Entergy Operations, Inc.
1448 S.R. 333
Russellville, AR 72802
Tel 479-858-3110

1CAN061201

SUBJECT: License Amendment Request
Technical Specification Change Associated with Main Feedwater Valves
Arkansas Nuclear One, Unit 1
Docket No. 50-313
License No. DPR-51

Analysis of Proposed Technical Specification Change

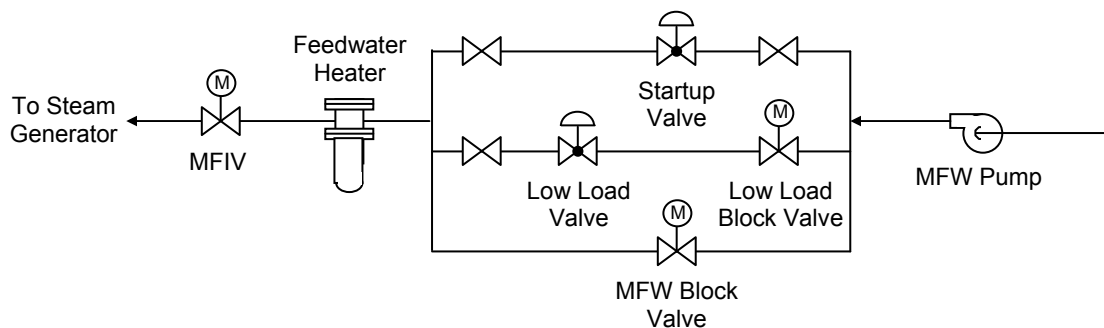
At lower power levels, SG level is maintained through modulation of the Startup and Low Load Feedwater Control Valves (see simplified drawing). The control valves are sequenced in operation so that the Startup Control Valve opens first, followed by the Low Load Control Valve. Differential pressure across the control valves is maintained through modulation of MFW pump speed.
